E15-21

Original Proposal

IBC: 1006.2.2.2, 1006.2.2.3 (IFC:[BE] 1006.2.2.2, 1006.2.2.3)

2021 International Building Code

Figure 1B: Example detail for Type III-A exterior wall-floor intersection with two rim boards

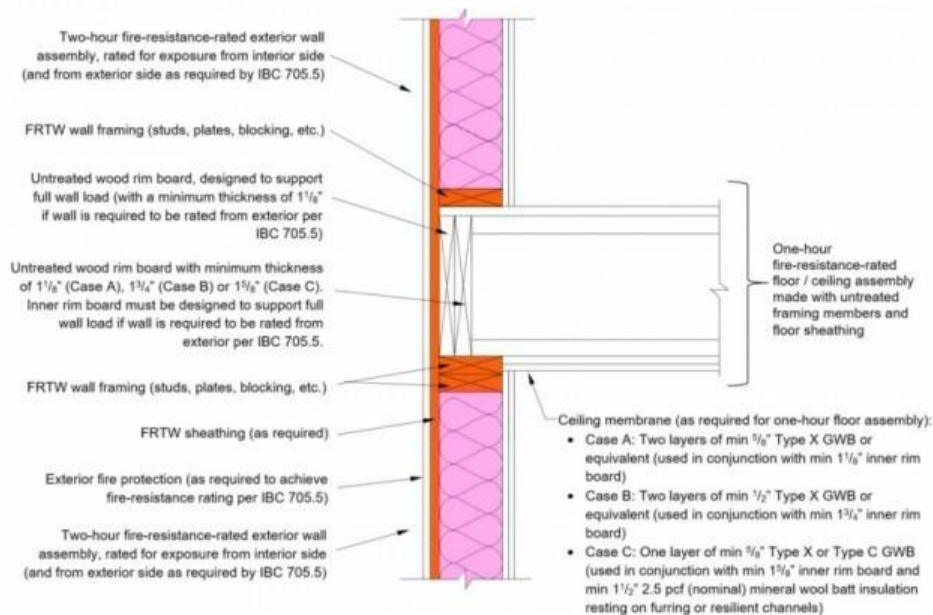
[Below page 7 from DCA 3 here: Figure 1B example detail and accompanying “methodology” notes]
